HIDDEN CREEK LLC ADDITION TO SEDGWICK COUNTY, KANSAS

RE: SUB 2003-137 -- One-Step Final Plat of Hidden Creek L.L.C. Addition

STAFF REPORT
(One-Step Final Plat Approved 12/04/03)

CASE NUMBER: SUB 2003-137 -- HIDDEN CREEK LLC ADDITION

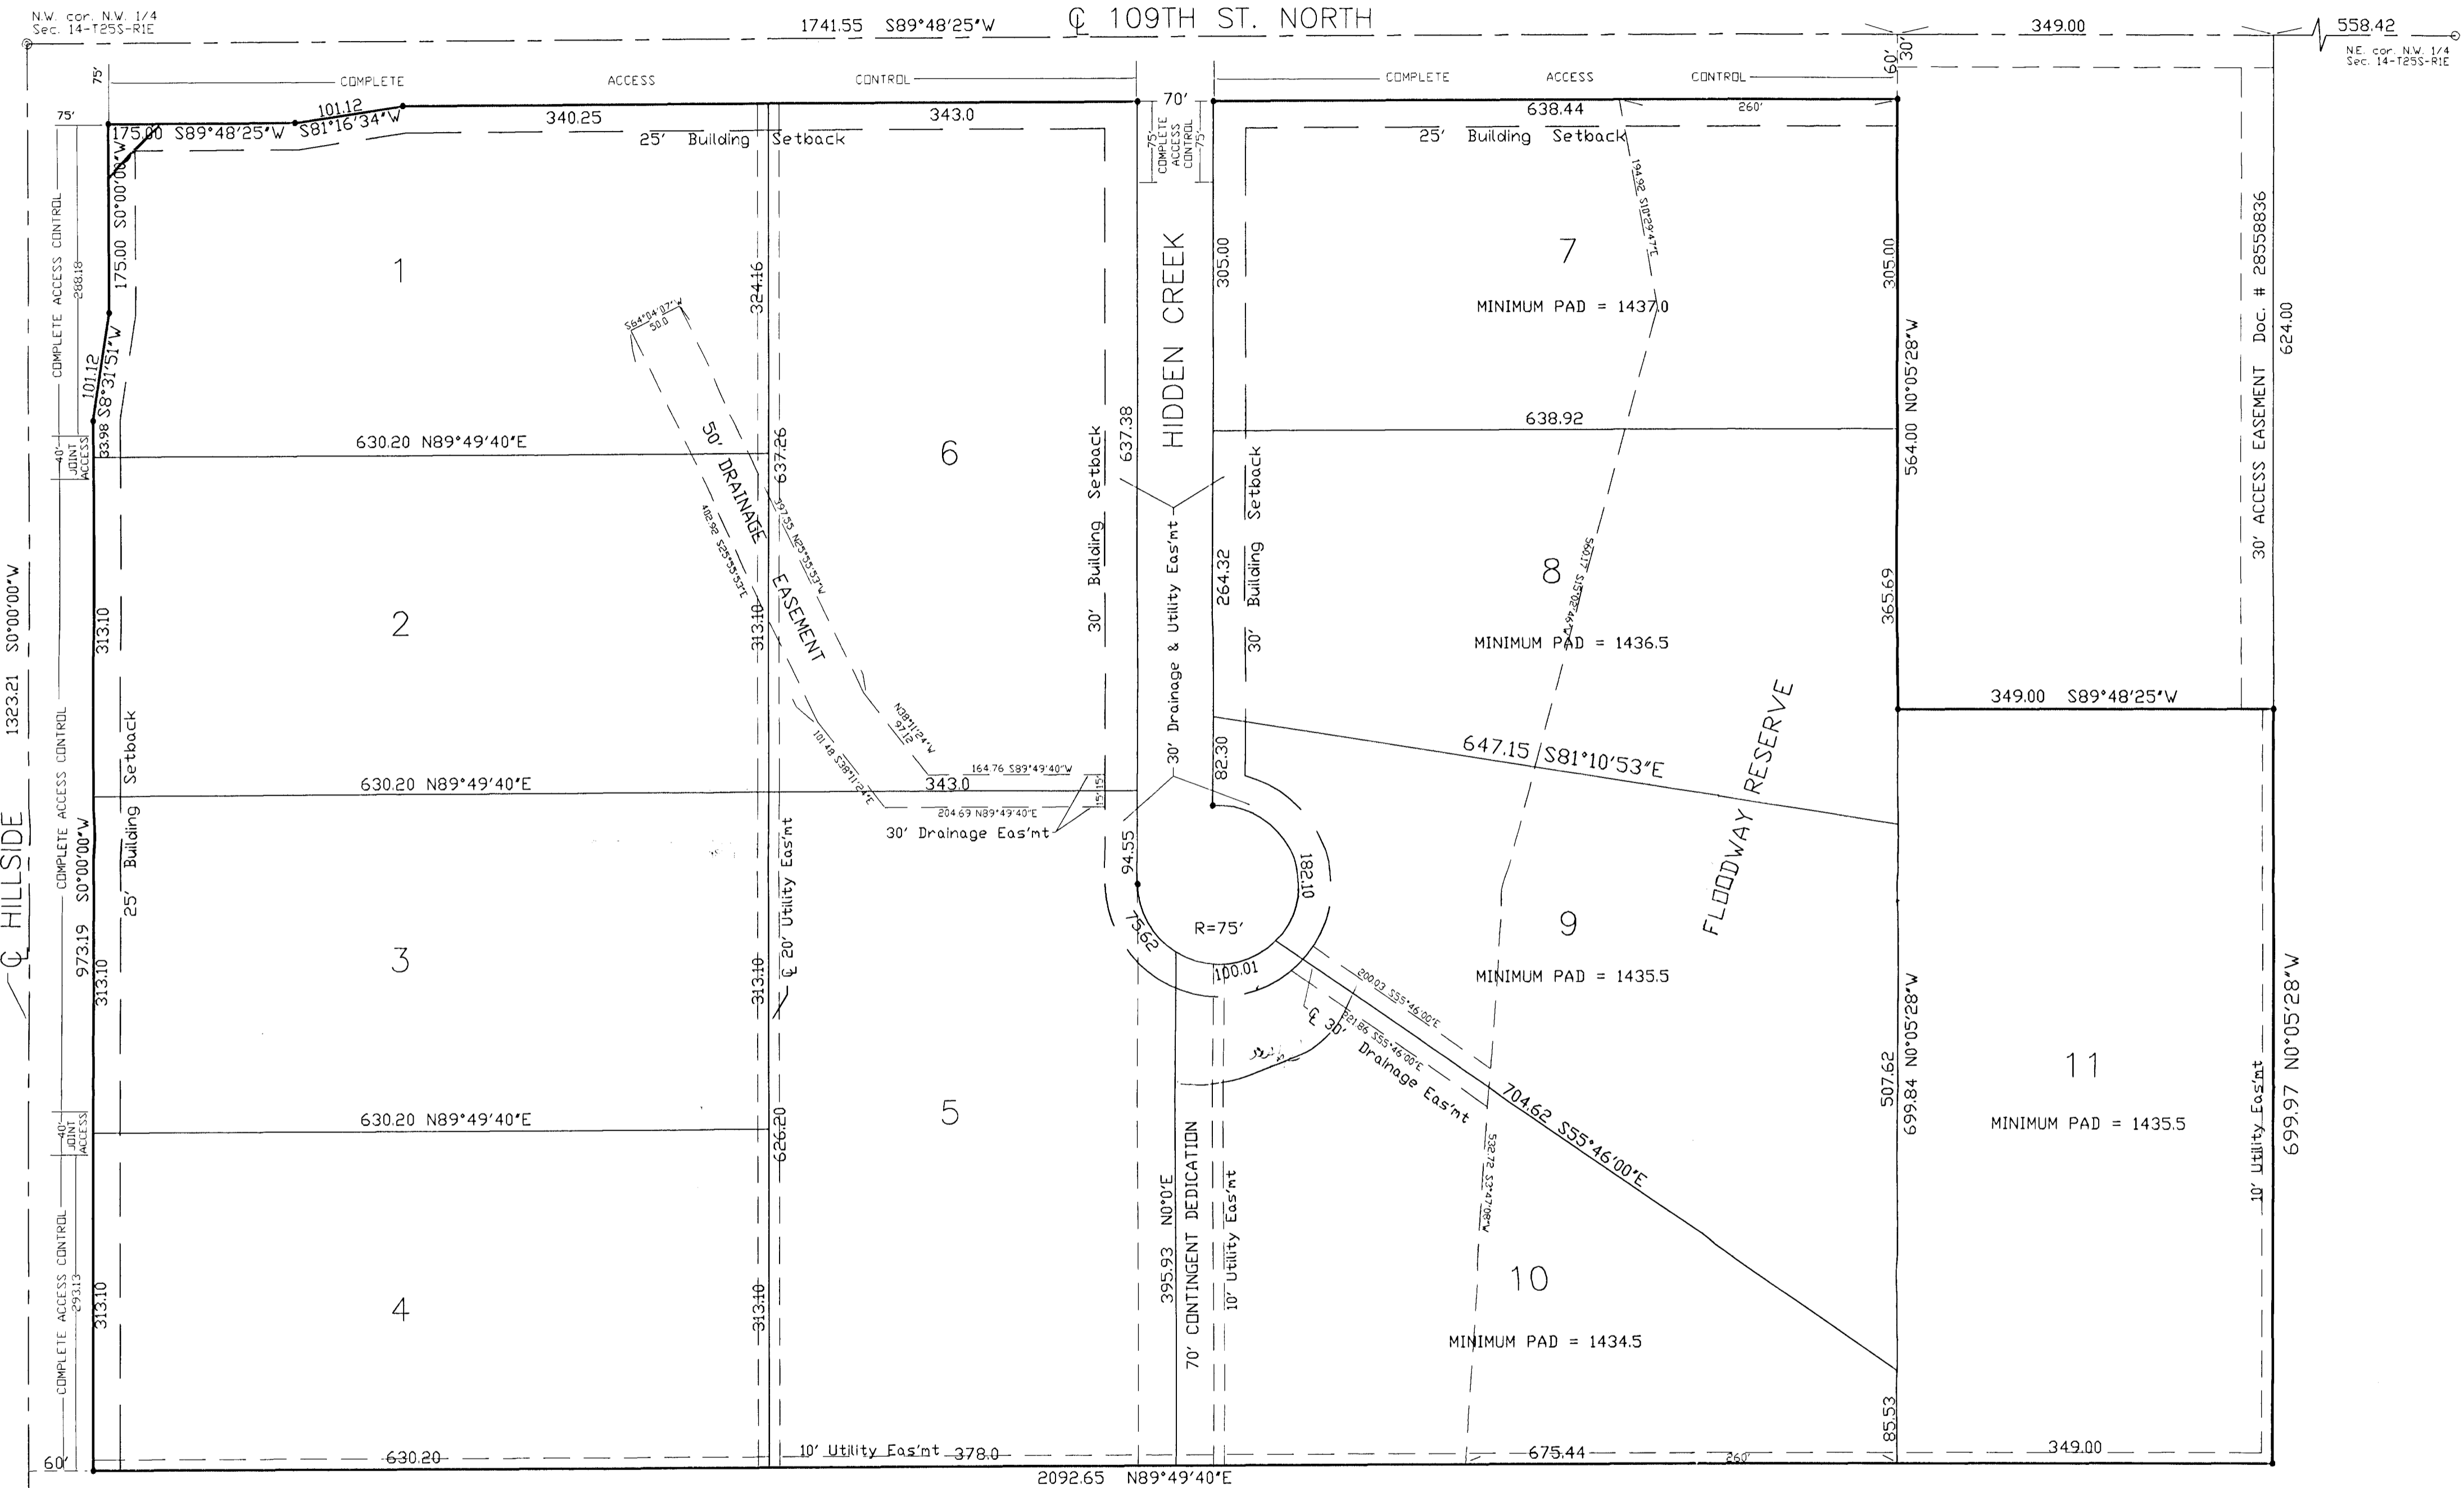
- D. **County Engineering** needs to comment on the status of the applicant's drainage plan. ***A flood study and drainage plan are needed. Floodway reserves are needed.***

- G. In accordance with Access Management Regulations for County plats, complete access control is required for arterials intersecting with local streets. Complete access control of 75 feet is needed along Hidden Creek Ct from 109th St. North.

- H. **County Engineering** needs to comment on the access controls. The plat denotes two joint openings along Hillside. *County Engineering has approved the access controls. Dimensions of the access openings are needed. The appropriate arrows need to be included for the complete access control platted along 109th St. North. The plattor's text shall be corrected to reference "Lots 1-4" having access at two locations to Hillside.*

- J. In accordance with the Subdivision regulations for suburban subdivisions, the turnaround needs to be increased to a 75-ft property line radius.
- K. The Access Management Regulations requires a 60-ft half-street right-of-way width along rural arterials. The Regulations also requires an additional 25-ft x 25-ft corner clip at the intersection.

- N. The Applicant is advised that if platted, the building setbacks along Hidden Creek Ct must be 30 feet to conform with the Zoning setback standard for the RR, Rural Residential District.

- O. Lot 10 does not conform with the 200-ft lot width standard which is measured at the building setback line. An increase in the distance of the building setback from the road would meet the standard.

- P. Approval of this plat will require a waiver of the lot depth to width ratio of the Subdivision Regulations for Lot 9. The Subdivision Regulations state that the maximum depth of all residential lots shall not exceed 2.5 times the width.

- Q. **GIS** needs to comment on the plat's street names. Hidden Creek Ct needs revised to "Hidden Creek".
- R. The Applicant should consider submitting the final plat with a revised name as an Addition now within Wichita exists with the name "Hidden Creek Addition".

- S. For lots fronting on cul-de-sacs, the lot frontage is required to be 50% of the required lot width (200 feet). Lot 10 does not meet this 100-ft frontage requirement.

- CC. The representatives from the utility companies should be prepared to comment on the need for any additional utility easements to be platted on this property. Westar Energy and SBC requests additional easements. Subdivision Committee also requested urban scale utility easements.
